PRELIMINARY PLAT REVIEW PUBLIC HEARING

FOR: Back Forty Subdivision
WHERE: N of Victor; W 7000 S
PREPARED FOR: Planning and Zoning Commission
Public Hearing of June 10, 2025

APPLICANT AND LANDOWNER: HCRK LLC

ENGINEER: Taylor Cook

Figure 4. Preliminary Plat

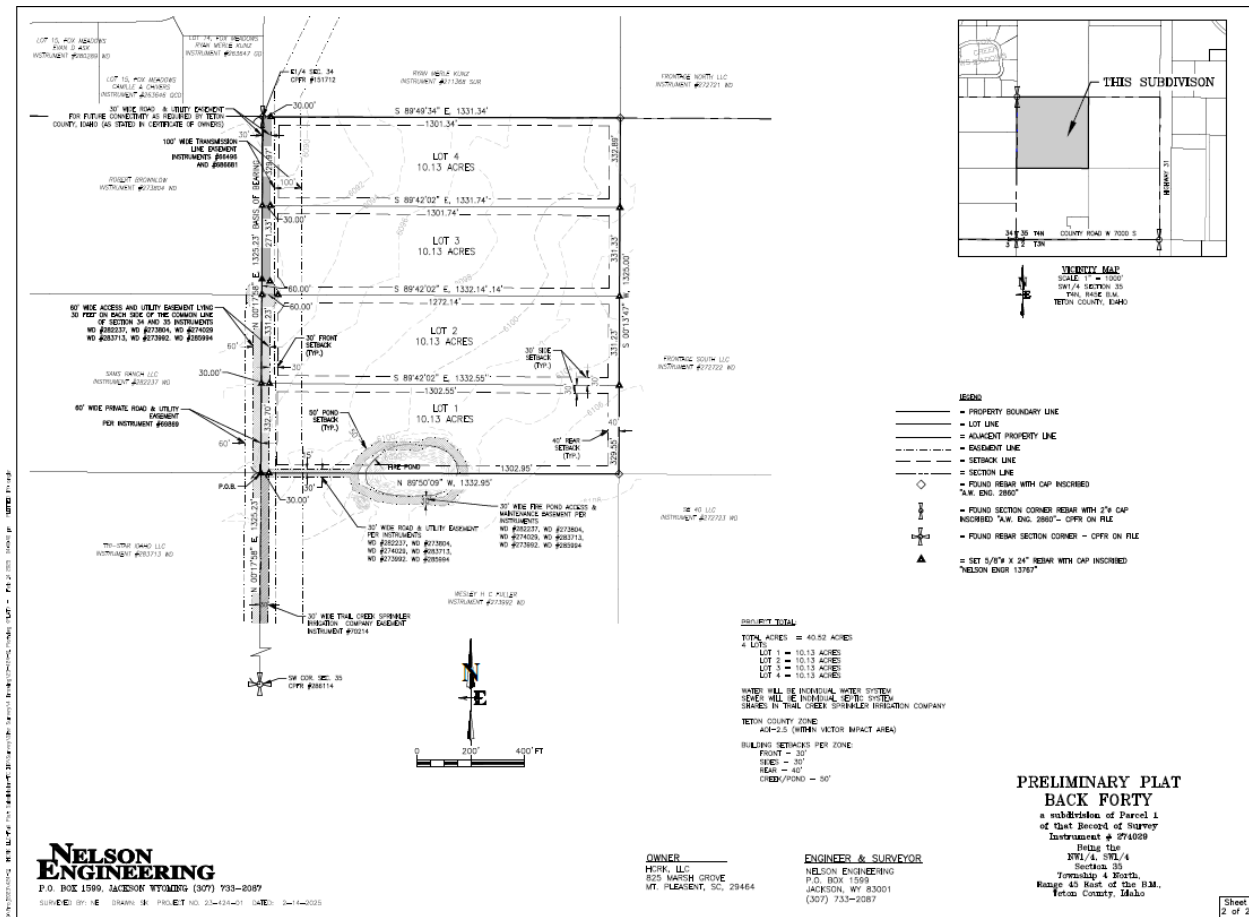
- b. Interior subdivision roads will need to be built to County Road Standards.
 - c. Cul-de-sac requires a 50-foot minimum radius **The applicants have reconfigured the roads entirely with the rearrangement of the subdivision with reduced lots. The new proposed access relies on two shared access points from 1000 West. The County Engineer has reviewed the modified layout.**

- A clear distinction between residential development and open space/agricultural areas
- The zoning of the parcel is AOI-2.5 acre average density. All proposed lots are eight acres or larger which comply with the minimum zoning district requirement of 1-acre minimum lot sizes.

- The subdivision has an interior subdivision road proposed. All lots must be accessed from the interior subdivision road.
 - 6-1-10: Site plan for development should show the cluster box for USPS for postal delivery service. No mailboxes may be located in the sidewalk or right-of-way

- 6-2-4: Stub roads. Applicant submitted an easement to the eastern property. Stub road should be constructed per comments from the City of Victor.
 - 6-4-3: Electric and telecommunications are required utilities to the development.
